Preliminary Consultation
MONTGOMERY COUNTY HISTORIC PRESERVATION COMMISSION
STAFF REPORT

Address:	10012 Menlo Ave., Silver Spring	Meeting Date:	10/9/2024
Resource:	Nominal (post-1935) Capitol View Park Historic District	Report Date:	10/2/2024
Applicant:	Alpha Houses LLC (Salem Badawy, Agent)	Public Notice:	9/25/2024
Review:	Preliminary Consultation	Staff:	Dan Bruechert
Proposal:	Partial Demolition, Two Story Addition, and Tree Removal

Proposed site plan for 10012 Menlo Ave

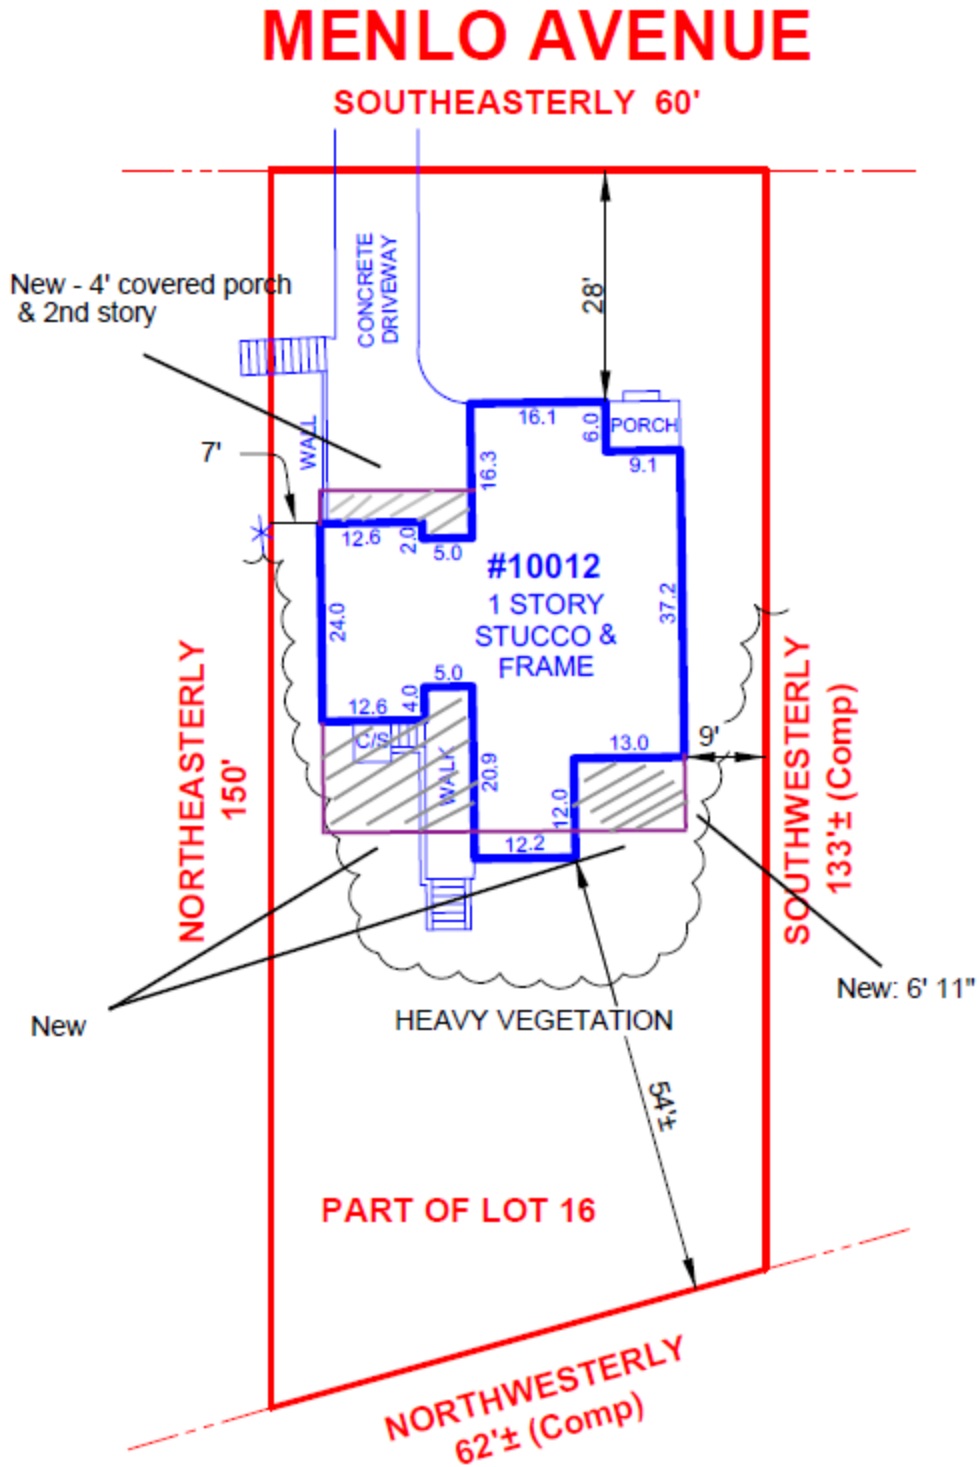
The application materials also include a wood privacy fence, stone retaining walls, and concrete stepping stones. The level of detail in the proposed site plan does not provide enough detail to show the location of these proposed features, so Staff cannot provide any feedback about the appropriateness of the features. However, Staff finds that, in general, wood fences – depending on the height – are generally appropriate, as are block retaining walls, and concrete steppingstones.

- Drawings of the existing building;
- Detailed elevation and plan drawings of the proposed house with a sufficient level of detail to effectively evaluate the proposed work;
- Any renderings should be shown without trees as the HPC is charged to evaluate proposals in the absence of vegetation;
- An existing site plan with tree location, size, and species identified;
- All specification materials;
- Complete materials for the fence and hardscaping including locations on a scaled site plan and all material specifications and images;
- A detailed proposed site plan that includes the location of any alterations to the hardscaping and includes details for the dimension and appearance of any new hardscaping/significant re-grading;

Streetscape study along Menlo Ave.

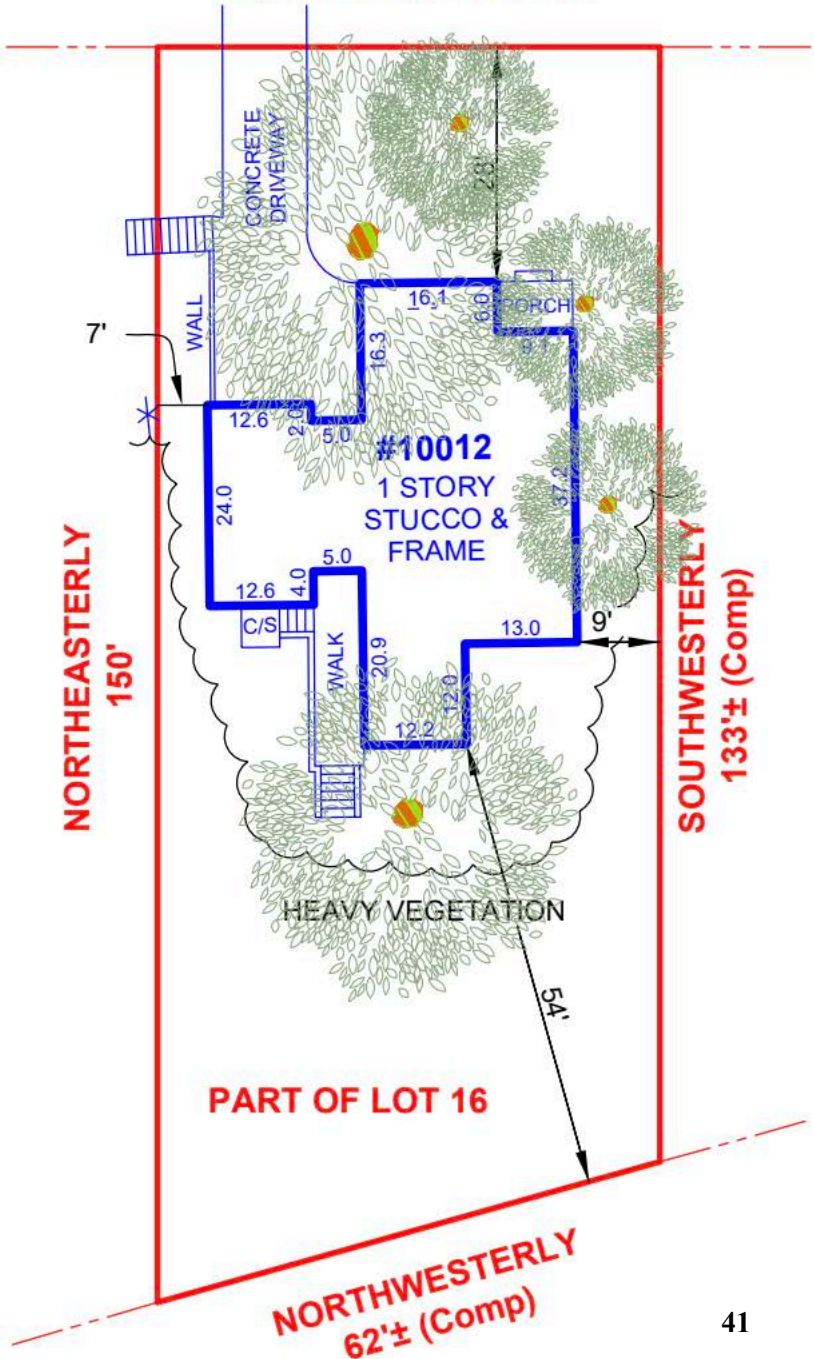
The applicant provided a streetscape study with the application materials, unfortunately, the study only shows the relative height, width, and elevation of the adjacent properties and does not accurately present the spacing between the houses, making the houses appear much closer than they are in reality. Nevertheless, Staff finds the proposed height is generally consistent with the 27’ (twenty-seven foot) height of both houses to the north.
